SITE PLAN REVIEW

LOT NO 3 REGISTERED PLAN

SIGNATURE:	
CLIENT	GOLD PARK HOMES
PROJECT/LOCATION	KLEINBURG GLEN-PH2 VAUGHAN, ON

DRAWING SITE PLAN

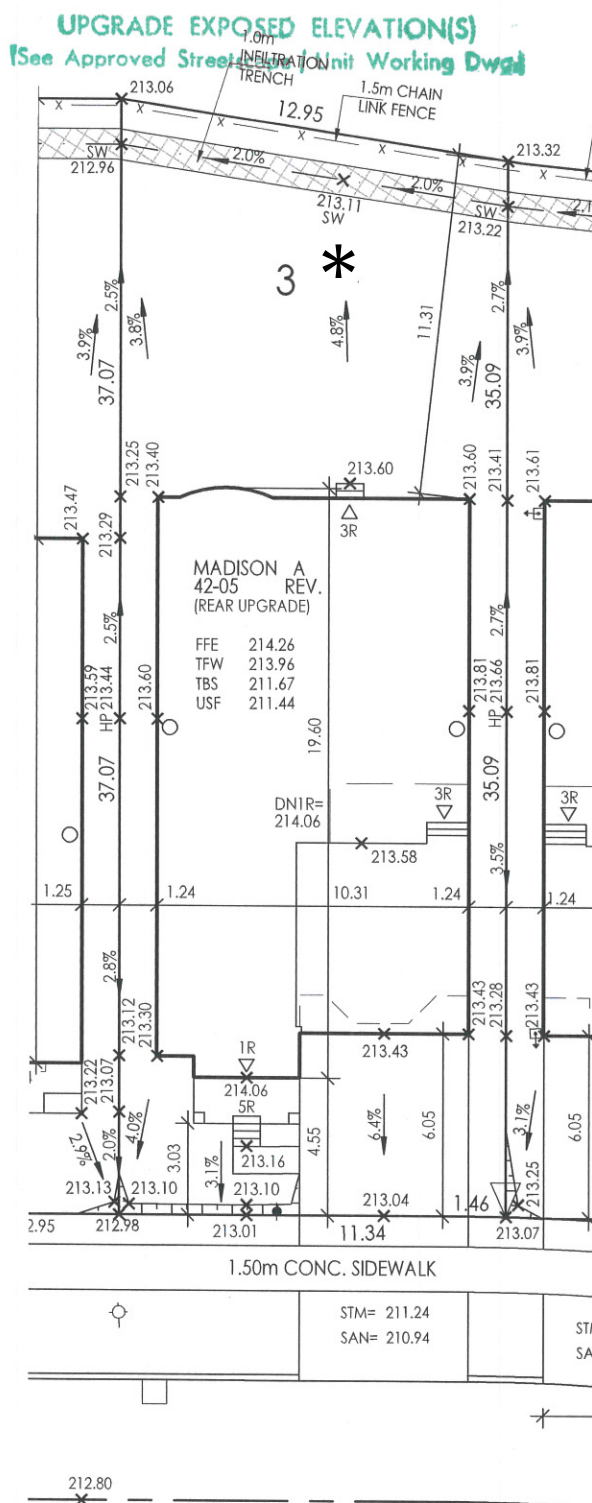
THE PROPOSED LOT GRADING AND DRAINAGE IS APPROVED AS BEING IN CONFORMITY WITH THE OVERALL APPROVED GRADING PLANS FOR THE SUBDIVISION.

NO COMMENT ☒ REVIEWED BY SK
COMMENTS AS NOTED ☐ DATE Mar. 13, 2017
